**CORRO-CONSULTA**

**MEMORANDUM – REDACTED VERSION – JULY 19, 2007**

**Subject:** Update of Current Knowledge Regarding the State of Integrity of OCNCS Drywell Liner and Comments Pertaining to Aging Management Thereof

**Subject: Review of Fitness for Service Assessment of Oyster Creek Dry Well  
on the Basis of Extended Data Analysis**

**Figure 3**

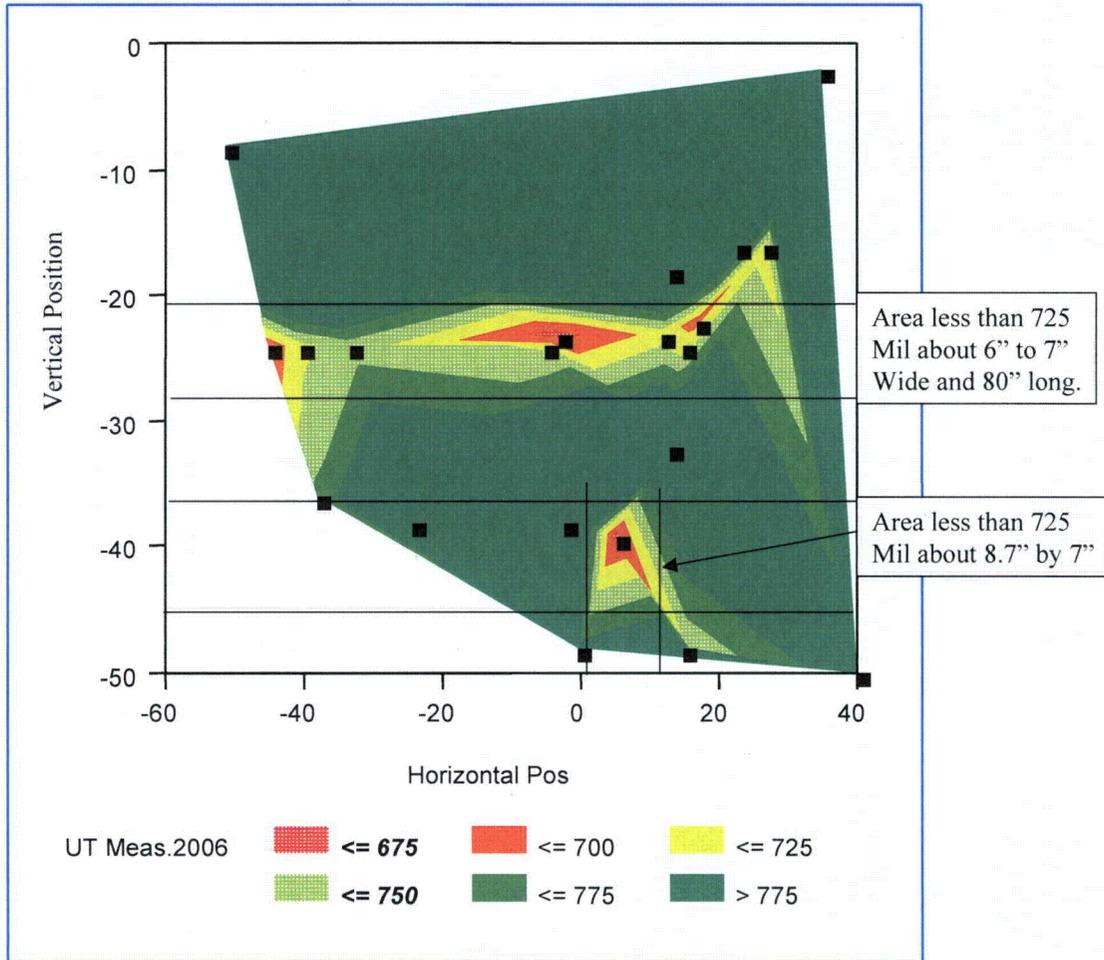
Figure 3 shows the contours for Bay 1 obtained with the data from the 2006 inspection. The general shapes are the same as in Figure 2 except that here we have sizeable areas with residual wall thicknesses below 725 mils. The unexpected thing is

that these areas seem to extend on the left beyond h -40 inches but no measurements are available to verify whether AmerGen did in fact manage to capture all of the most corroded areas as claimed.

Based on Figure 3, together with an assessment of the accuracy (reliability) of the data one must conclude that there is a good likelihood that the entire bathtub ring area extending from 40 to -40 inches on the horizontal axis and from about -30 to perhaps -20 inches on the vertical axis is below the 0.736 inch criteria for general thinning and is, much larger than the one square foot acceptance criterion. (Of course, since this area is the most corroded, it will taper off to higher wall thickness on both sides of the vertical axis). The corroded area is indeed shaped quite irregular, but one could venture a guess that the contoured areas below 750 mils are of the order of 4 to 7 square feet all together. This estimated area does not include the area to the left of -40, which probably contains additional area below 0.750 inches.

Figure 4

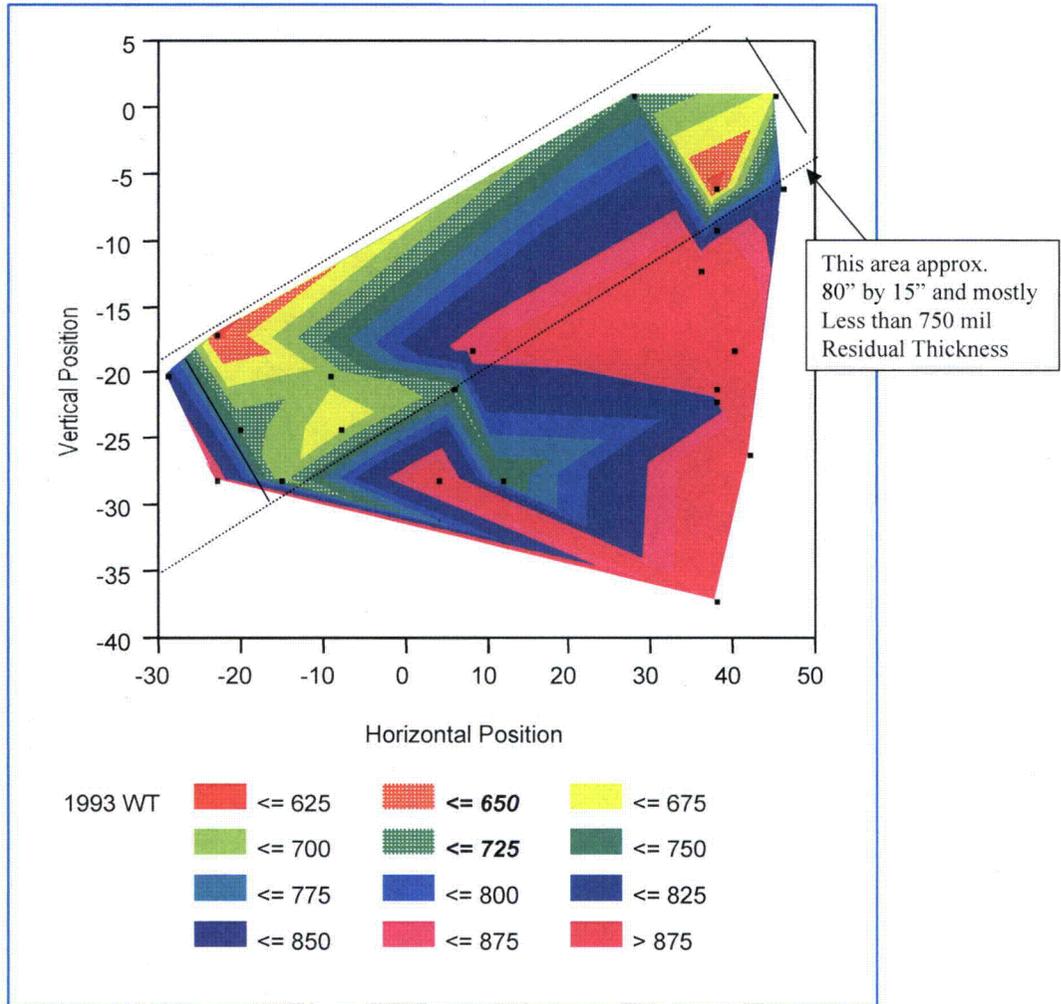
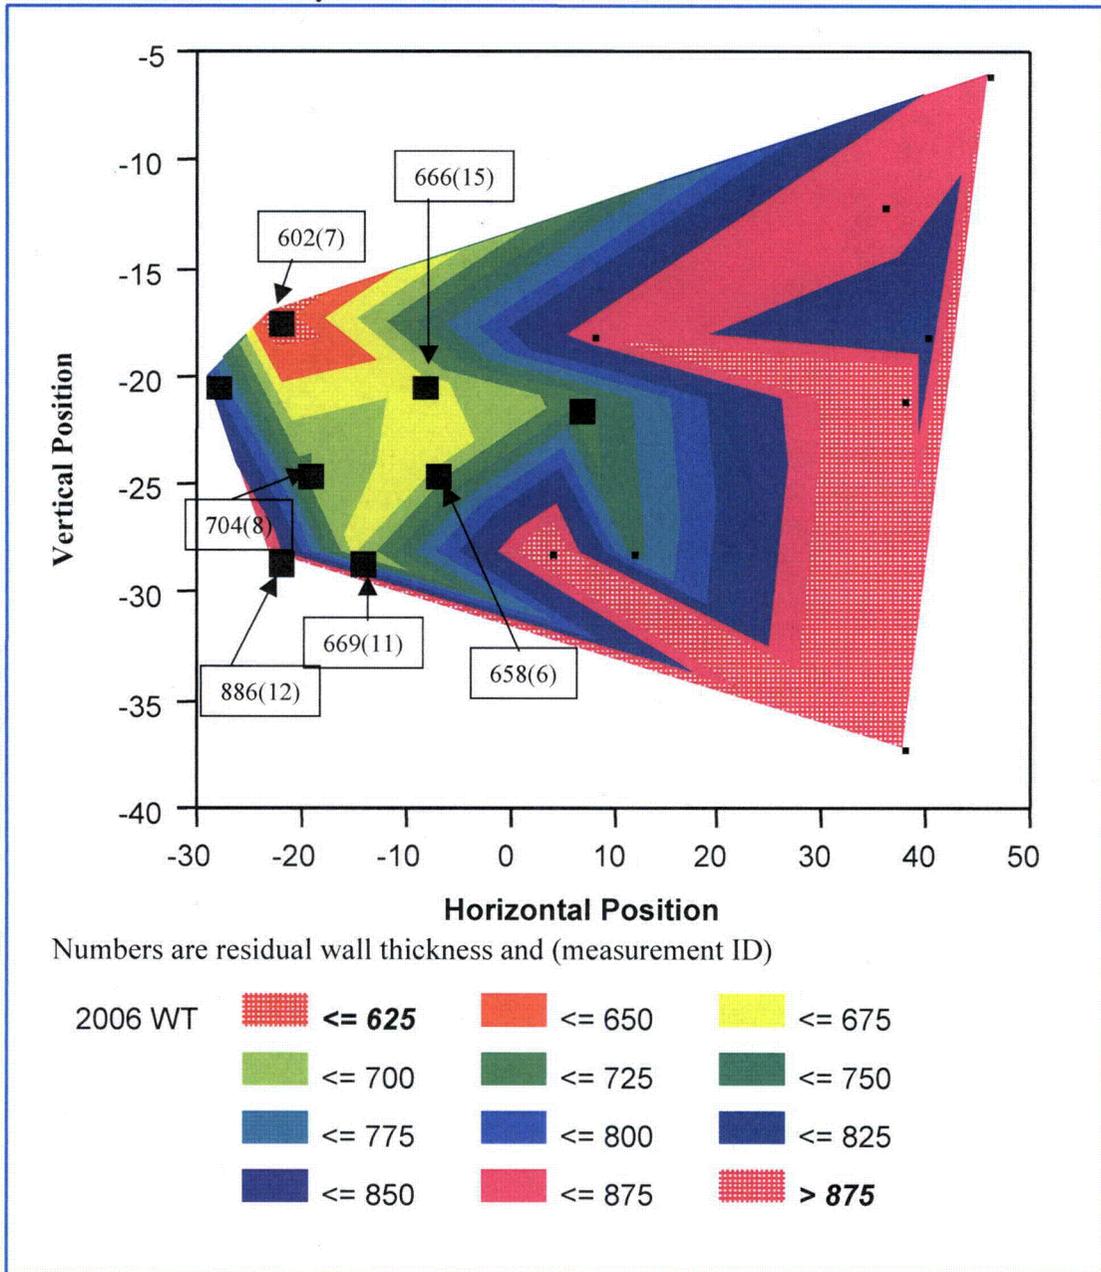
**Figures 4 and 5** show the contours for Bay 13, 1992 and 2006 data, respectively. Here large areas exist with wall thicknesses below 700 mils and at least two seemingly unconnected areas where the residual wall thickness is less than 650 mils. It could be argued that those heavily corroded areas are less than 1 square foot and therefore are still acceptable according to the 636 mil criterion. However, the heavily corroded area on the left hand side (-20, -20) has not been further explored. One therefore does not know whether it might extend further. Similarly, the area on the right ((40, -7), clearly showing a fairly deep pit, was not further explored and was not even measured in 2006. While in Bay 1 the bathtub ring was at elevation -20 to -25 (from the reference point) in Bay 13 there is no clearly prominent bathtub ring. This may be because it was not there, but it may also be because the measurements were not extended toward elevation -15 and -10. We are therefore left with a great uncertainty as to the true extension of the damage in this Bay.

Figure 6

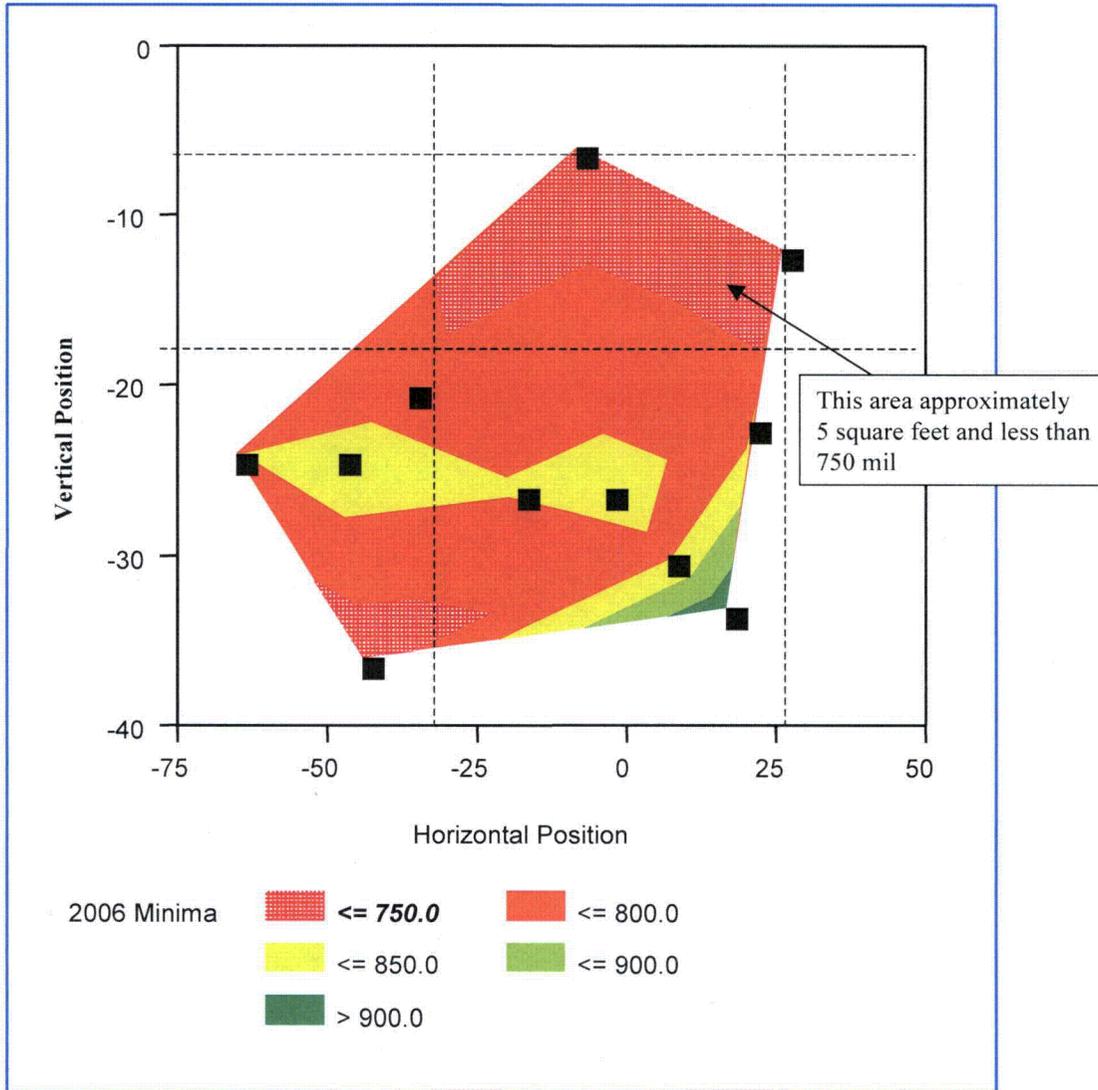
**Figure 6** shows the contours for Bay 15. There is a heavily corroded area at elevation -10 with an extension of 1 ft by about 4.5 feet. However, this area was explored only with 2 measurements and was not extended beyond about 2 feet either side of the centerline. It appears that the majority of the measurements occurred in the non-corroded zones. Interestingly there appears some serious corrosion near the sandbed bottom, but the occurrence was not further explored either.

Figure 7

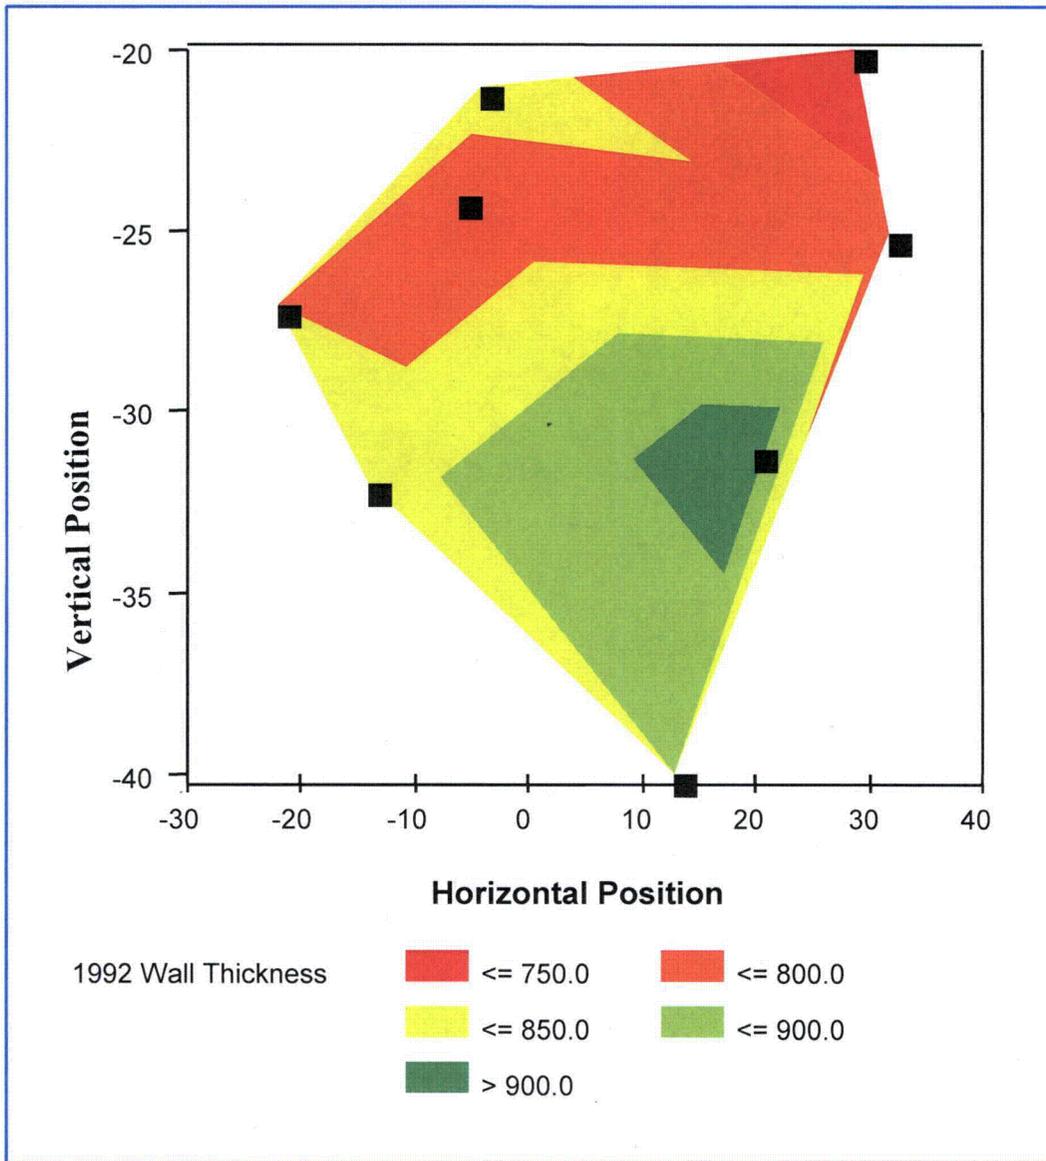
**Figure 7** shows the contours for Bay 11. Again there is a suggestion of severe corrosion at elevation -20 and no further exploration into the bathtub ring area. Once again, the extent of this area is highly uncertain because it was not further defined by additional UT measurements.
